TLZ07 Cassette Tape Drive and AutoLoader

Owner's Manual Supplement

May 1995

This supplement provides updated information to the TLZ07 Cassette Tape Drive and Autoloader Owner's Manual, EK-TLZ07-OM. A01.

Figure 1   Revised Version TLZ07-DA Tabletop Tape Drive

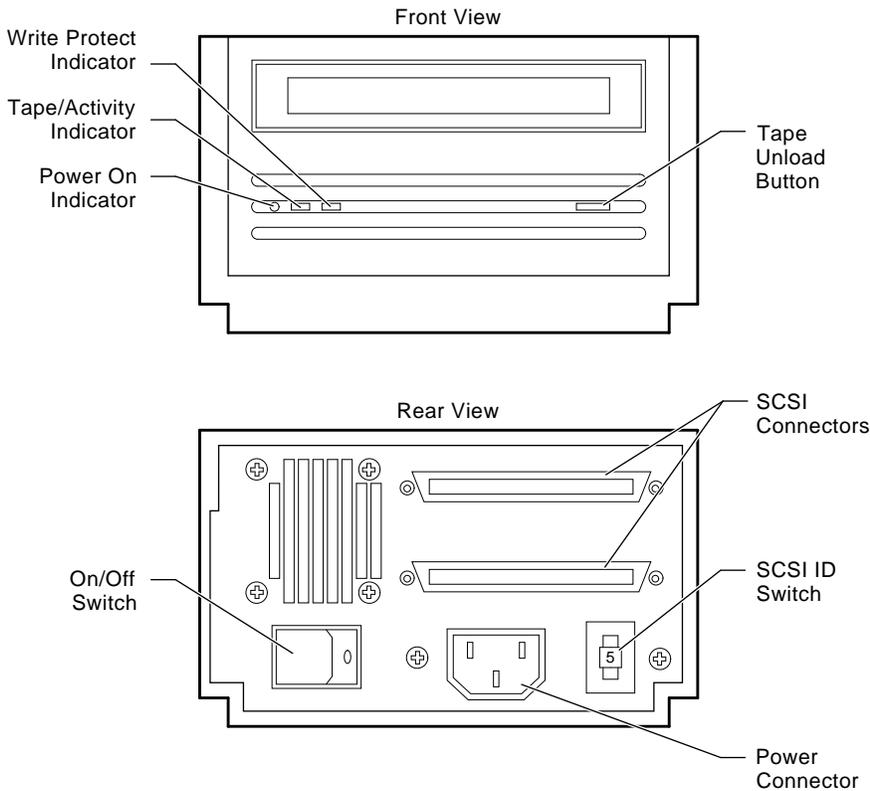
Figure 1 shows the front and rear views of the revised version TLZ07-DA tabletop tape drive. The tape/activity indicator, write protect indicator, and tape unload button have been repositioned with respect to the TLZ07-DA tabletop tape drive shown in Figure 1-1 of the owner's manual. There is a slight difference in the operation of the LED indicators between the original version and the revised version. Section 4 explains the difference. Otherwise, they are identical. To operate the revised version, refer to the owner's manual.

Figure 2 Revised Version TLZ07-AA/-BA Tape Drive

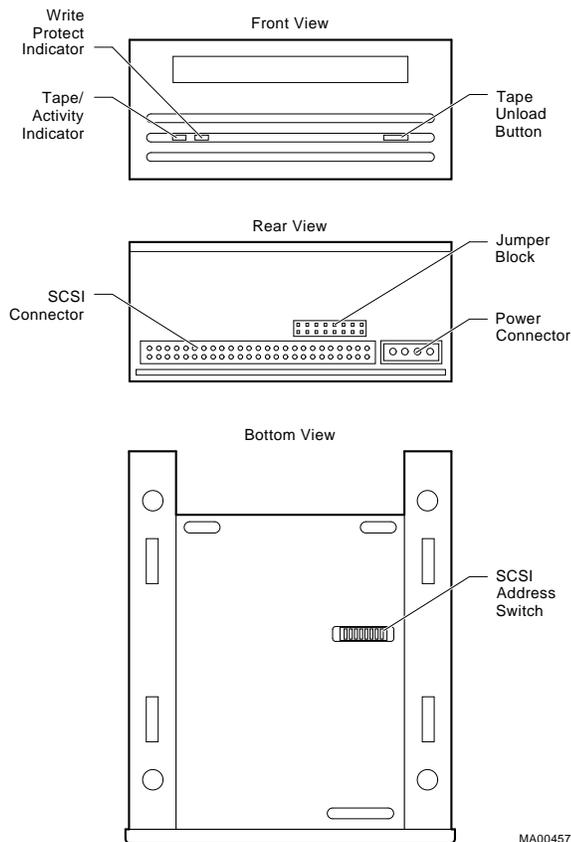
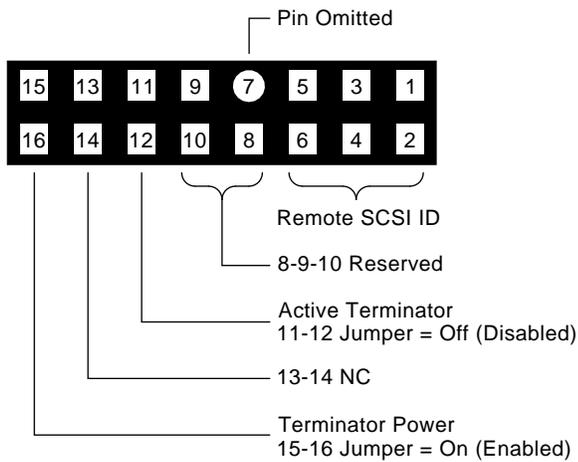
Figure 2 shows the front, rear, and bottom layouts of the revised version TLZ07-AA/-BA tape drive. Figure 1-2 in the owner's manual shows the layout of the original TLZ07-AA/-BA tape drive. Refer to Figure 3 for remote SCSI ID and option jumper settings located on the rear of the drive. Figure 4 shows SCSI ID and option switch settings located on the bottom of the drive.

There is a slight difference in the operation of the LED indicators between the original version and the revised version. Section 4 explains the difference.

Figure 3 Revised Version TLZ07-AA/-BA Tape Drive SCSI Jumper Settings

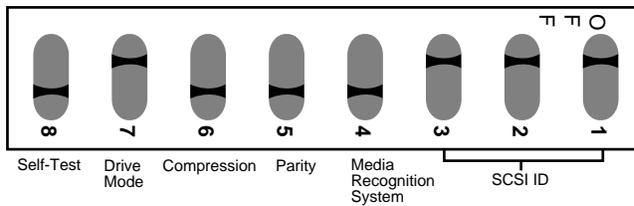
This subsection defines the revised version TLZ07-AA/-BA jumper settings.

- Remote SCSI ID (Pins 1–6). The factory default setting is **NO** jumpers installed. If you are not using a remote SCSI ID switch, refer to Figure 4 in this supplement for instructions on how to set the SCSI ID using the switchpack on the bottom of the drive.

- Active Terminator (Pins 11,12). The factory default setting is **NO** jumper installed, terminators disabled. To enable the terminators, place a jumper on pins 11 and 12.

- Terminator Power (Pins 15,16). The factory default setting is jumper installed, Term Power enabled. To disable Term Power, remove the jumper on pins 15 and 16).

- Pins 8, 9, and 10 are reserved.

- Pins 13 and 14 are unused or not connected.
